SUBJECT: Margeson Drive Public Engagement

MARGESON DRIVE: HIGHWAY 101 to LUCASVILLE ROAD

Alignment Plan

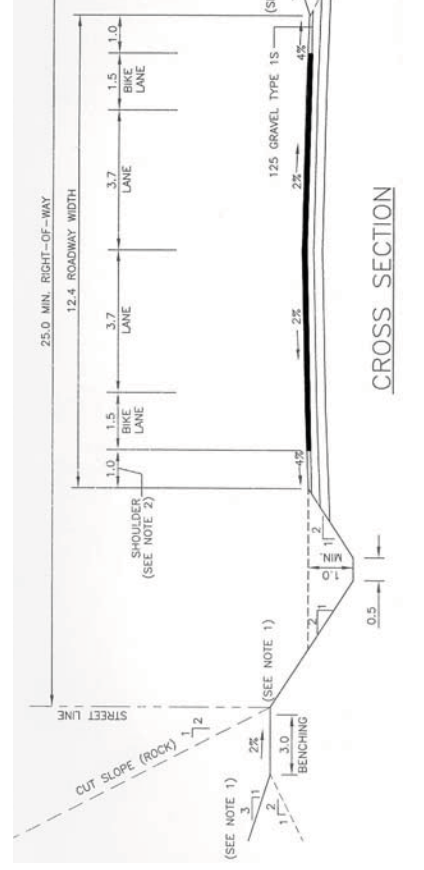
<u>More urban sprawl.</u>
Maps at this public meeting should <u>all</u> show proposed roads where they starts, where they go and where they end.
On the map dated October 2013, Margeson drive is shown in a green line which runs parallel to Lucasville road until it joins into the existing Cranley road. This is unsafe on many levels. I suggest that Margeson drive should run completely parallel to Lucasville road. It should end at a traffic circle on Hammonds Plns road. P.S. The existing traffic lights at Lucasville road and Hammonds Plns road should have a traffic circle A.S.A.P.
The termination of Margeson Drive to Cranley makes no sense considering the perfectly excellent location at the power line just a short distance away. This would eliminate <u>any</u> hassle for home owners. Considering this power line is proposed to expand it is the logical choice. We don't need any more traffic. Please do the right thing.
